R.C.A. Victor Co., Inc.

Model: 35X

CHANGES, NOTES

RCA MFG. CO., INC.

Oscillator Coil—Stock No. 36801

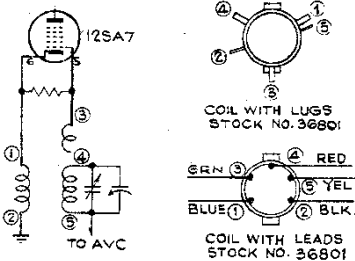
The oscillator coil (Stock No. 36801) drawing, as shown in the service notes of Models 11X1 and 35X, is incorrect.

Two types of Stock No. 36801 coils are in use. One type has terminal lugs, the other has leads. Both types are shown in the accompanying sketch.

Crystal Pickup Connections, QU51C

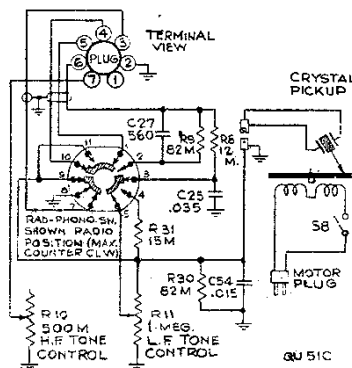
The schematic "Crystal Pickup Connections (QU51C)" in the QU51C service note is in error in the connections to switch terminals 7, 9, and 11. The correct schematic is shown in the accompanying sketch.
